Access Compliance Report Public Rights-of-Way (Curb Ramps)

Main Street: COPA_DE_ORO_DR Cross Street: SILVER_FOX_RD Location: SE

ADA ID: RPRK211206175603 Ramp Type: Type 1 - Perpendicular Diagonal Initial Pass/Fail: Fail Overall Compliance: No Severity Score: 2

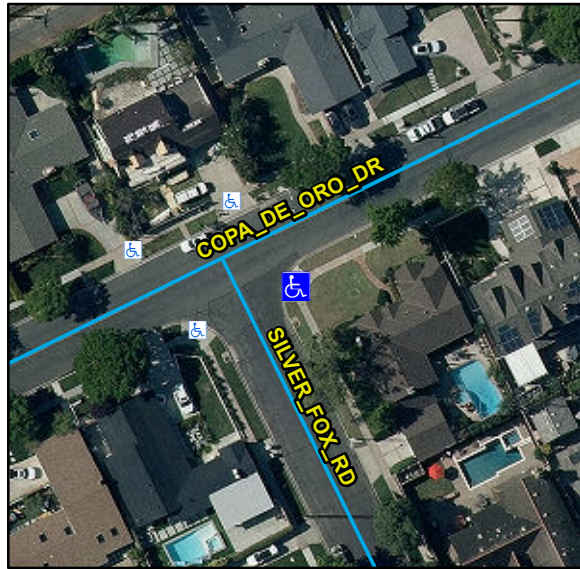
R304.2.2, R204.3, R304.5.3, STD 1115

Remove & Replace Curb Ramp With Two New Directional Ramps or Equivalent.
